JLRTB02052NAS1
TECHNICAL BULLETIN
16 SEP 2020

501-03

Rear Doors Difficult To Open

MODEL:	MODEL YEAR:	VIN:	ASSEMBLY PLANT:	APPLICABILITY:
Defender (LE)	2020 Onwards	000431 Onwards	Nitra (Slovakia)	5-Door

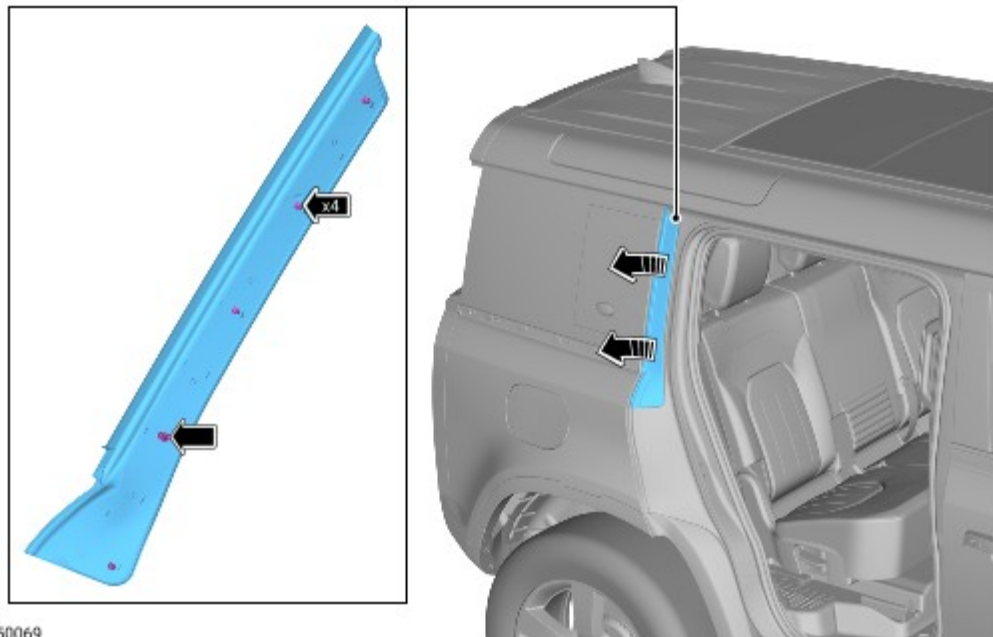
Check the alignment of the rear door(s) in the areas shown in the illustration.

SECTION	DESCRIPTION	GAP	PROFILE
A	Rear door to rear quarter	N/A	0.0 ± 0.5 mm
B	Rear door to rear quarter	3.5 ± 0.7 mm	0.0 ± 0.7 mm

Adjust the rear door(s) to be within tolerance (see TOPIx Workshop Manual section 501-26: Body Repairs: Vehicle Specific Information and Tolerance Checks - General Procedures - Rear Door Alignment).

E268337

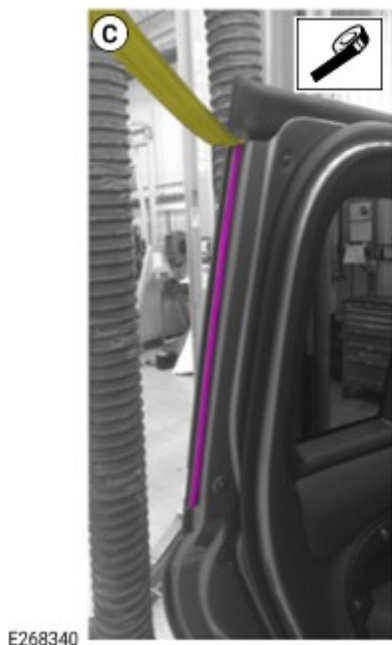
Install the new C-pillar exterior finisher trim.

- ■ Remove the adhesive tape backing.
 - ■ **Make sure the C-pillar exterior finisher trim protrudes 1-1.5 mm away from the rear quarter window, as shown in the illustration, before fully securing.** The image with the **RED 'X'** shows the C-pillar exterior finisher trim installed incorrectly behind the rear quarter window. The image with the **GREEN '✓'** shows the C-pillar exterior finisher trim installed correctly with a 1-1.5 mm protrusion from the rear quarter window.
-
